MANDATORY SERVICE BULLETIN NO. MSBD4-029

Type: DA 40 D

1.4 Subject

TEMPORARY REVISION
TR MÄM-40-122
Change of Emergency Procedures
in case of Engine Problems

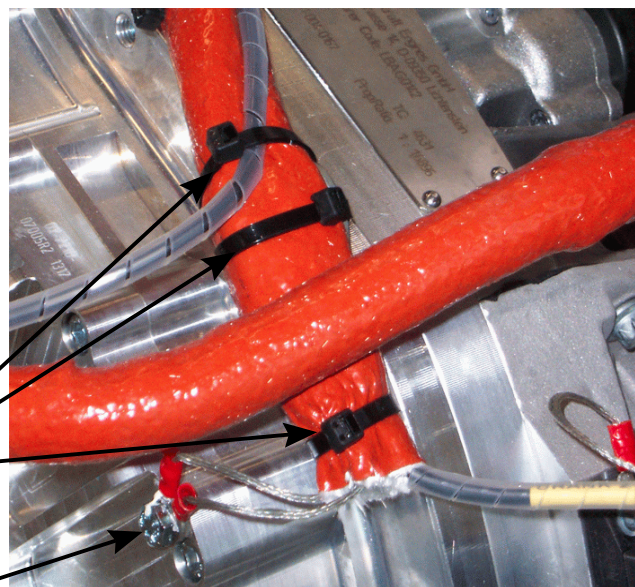
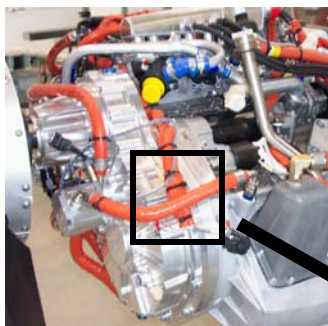
- b.1) remove upper cowling
- b.2) remove tie-raps of loom at indicated area

Tie-Raps to be removed

Ground connection to be opened

- b.3) open connection to ground

SHUTOFF wire
(underneath shrink tube marked with yellow sleeve)

- b.4) push back fire sleeve and separate SHUTOFF cable (NOT PGEAR cable)
- b.5) remove carefully the heat shrink of SHUTOFF cable. Do NOT damage wires !
- b.6) check for insulation of pins
 - b.6.1) if NOT in compliance with TAE Repair Manual RM-02-01, Doc. No. 25.4 insulated, comply with TAE Repair Manual RM-02-01, Doc. No. 25.4, item 2 and subsequent
 - b.6.2) if in compliance with TAE Repair Manual RM-02-01, Doc. No. 25.4 insulated, comply with TAE Repair Manual RM-02-01, Doc. No. 25.4, item 3 and subsequent
- b.7) reconnect ground wires
- b.8) bring fire sleeve back into initial position to protect wires
- b.9) re-secure loom with tie-raps as shown on pictures
- b.10) check for loose ground connection and foreign objects
- b.11) reinstall upper cowling
- b.12) perform engine run up, check for proper function

Fig. 1 – after removal of connector

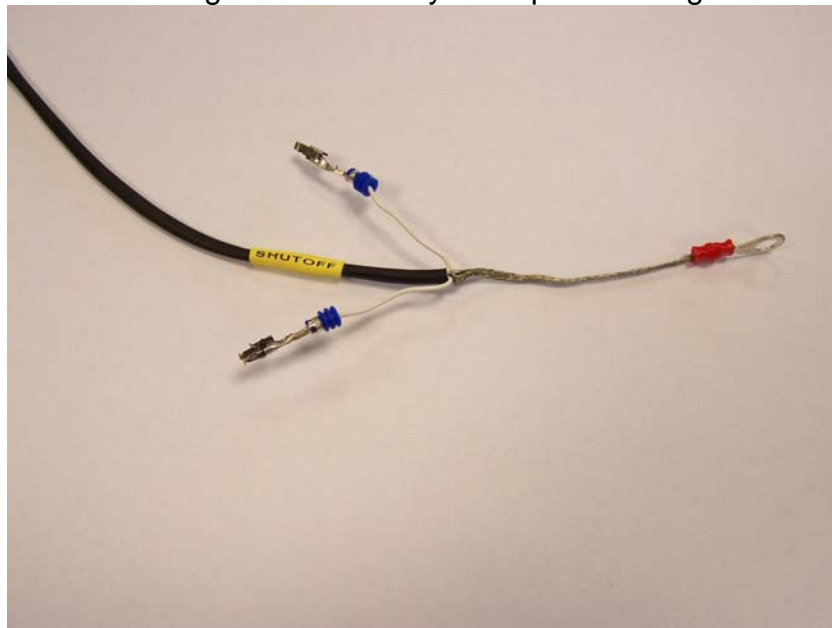
1. Remove shutoff connector housing by extracting the crimps using an extraction tool resulting in an assembly as depicted in Fig. 1.

Fig. 2 – after isolating the contacts

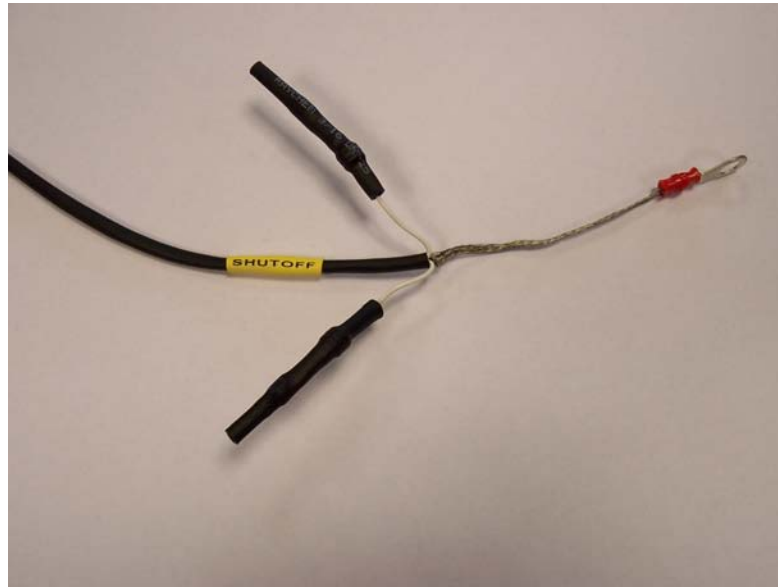
2. Wrap crimps and wire ends in 02-9150-52170R1 DR25 heat shrink tubing 3/16, 50mm and heat-shrink it to isolate the contacts. See Fig. 2 for an illustration of the finished isolated contacts.

Please note: Heat-shrink all DR25 tubing according to manufacturer instructions!

Fig. 3 – Finished Assembly

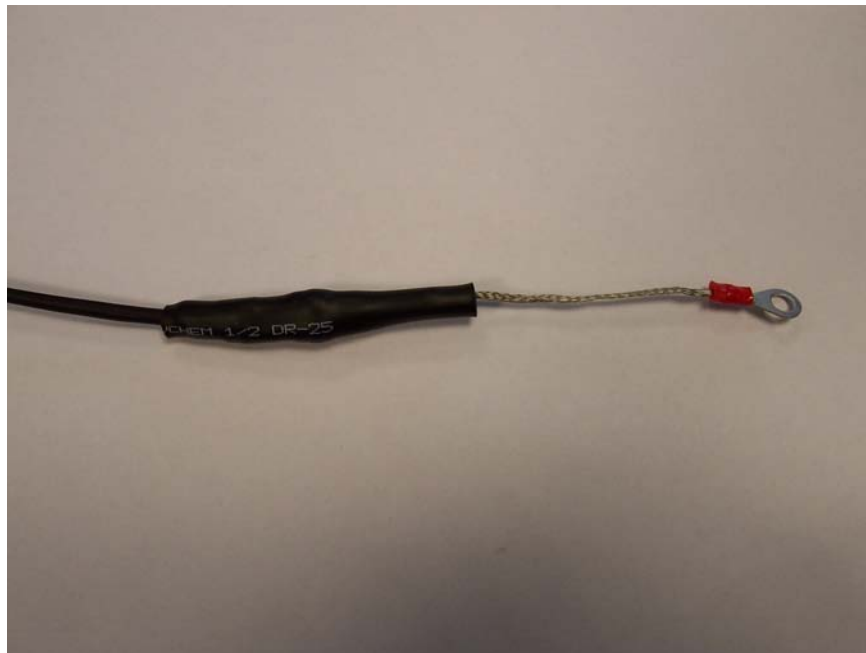
3. Bend back wire ends but leave shielding straight
4. Wrap the isolated wire ends and part of the loom but not the shielding in 02-9150-52171R1 DR25 heat shrink tubing 1/2, 80mm and heat-shrink it. See Fig. 3 for an illustration of the finished repair.

Please note: Reconnect shielding to engine ground after repair.

Fig. 1 – after removal of connector

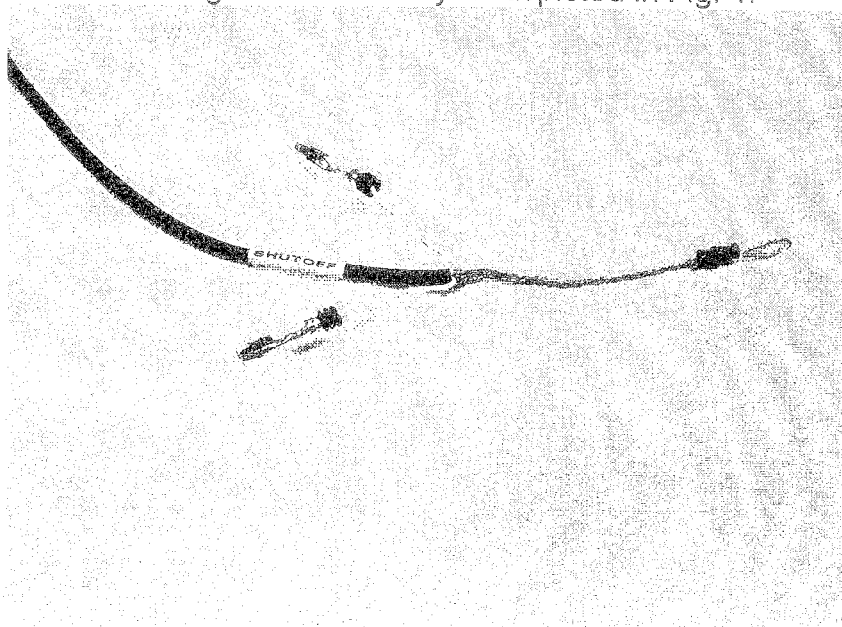
1. Remove shutoff connector housing by extracting the crimps using an extraction tool resulting in an assembly as depicted in Fig. 1.
